MONTGOMERY COUNTY HISTORIC PRESERVATION COMMISSION
STAFF REPORT

Address:	7312 Willow Ave., Takoma Park	Meeting Date:	3/6/2024
Resource:	Contributing Resource Takoma Park Historic District	Report Date:	2/28/2024
Applicant:	Tina Crouse Solar Energy World, Agent	Public Notice:	2/21/2024
Review:	HAWP	Tax Credit:	No
Case Number:	1055350	Staff:	Dan Bruechert
Proposal:	Solar Panel Installation

Figure 2: Proposed solar panel layout.

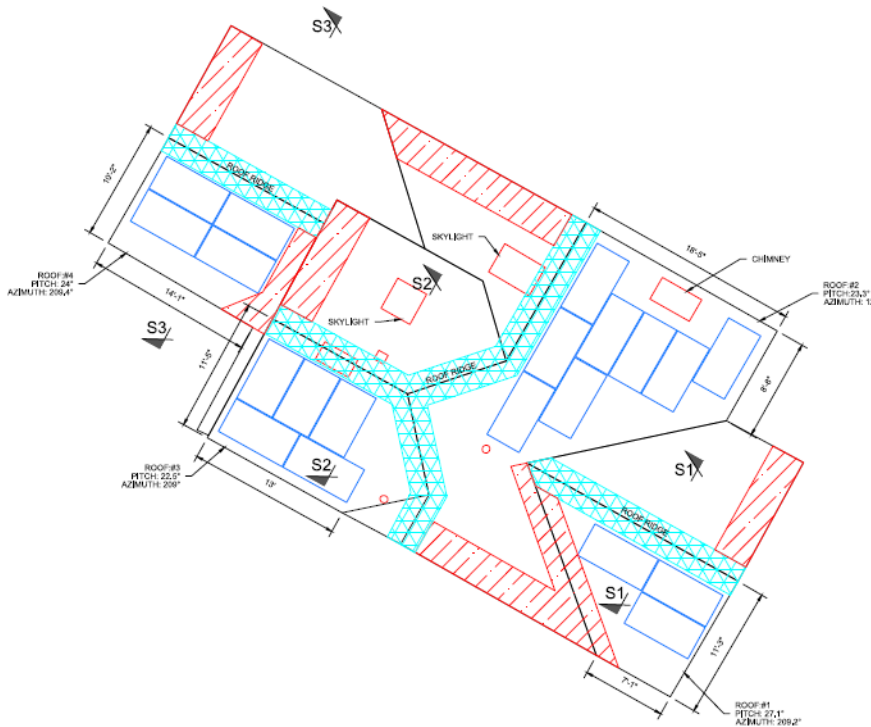
Two of the proposed arrays will be behind the side gable and therefore will not be visible from the public right of way. The three-panel array on the south (left) porch roof slope and the eight panels on the front roof slope with both be visible from the right-of-way when viewed in the absence of vegetation. Staff finds the two arrays, comprised of nine total panels, proposed behind the roof gable will not be at all visible from the right-of-way and not have an impact on the character of the house or surrounding district and should be approved as a matter of course.

To further evaluate the proposed eleven panels, Staff is guided by the adopted solar panel policy. In this instance, the preferred panel locations are either not available or have already been utilized: there is not sufficient space to install a free-standing array, panels will fill the useful locations on the rear roof slope and the non-historic rear addition, and the small one-bay detached garage is blocked by the existing tree canopy. The provided roof heat map demonstrates the proposed locations on the front of the house and the porch's left roof slope are the locations that will generate the most electricity.

Figure 4: Staff recommends the identified panel be eliminated from the proposal as a condition for approval.

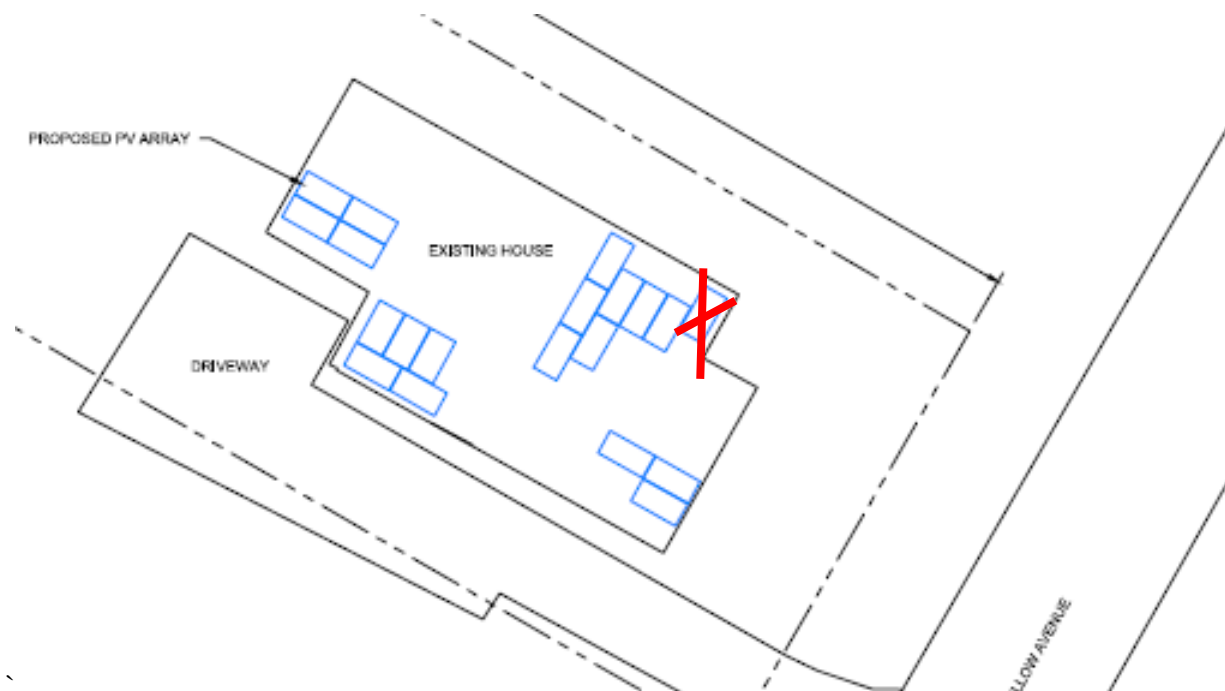
The 8 (eight) panels proposed on the front-facing roof slope, to the right of the porch are arranged to avoid the front porch gable and the chimney on the left (north) side of the house. Staff finds this arrangement of these panels is incompatible with the objectives of the solar policy which aims to install the panels in an organized arrangement. Staff recommends the HPC require the removal of the panel in the northeast corner of the house (furthest to the right and shown in *Figure 4* below) as a condition for approval for the HAWP. This panel is placed out of alignment with the rest of the panels in this group and is the one closest to the front of the house.

1. The solar panel in the northeast corner of the front roof slope shall be eliminated from the proposal. Revised plans showing this panel removed from the roof plan shall be submitted to Staff. Final approval authority to verify this condition has been satisfied is delegated to Staff.

1. The solar panel in the northeast corner of the front roof slope shall be eliminated from the proposal. Revised plans showing this panel removed from the roof plan shall be submitted to Staff. Final approval authority to verify this condition has been satisfied is delegated to Staff; under the Criteria for Issuance in Chapter 24A-8(b)(6), and (d), having found that the proposal will not substantially alter the exterior features of the historic resource and is compatible in character with the district and the purposes of Chapter 24A;
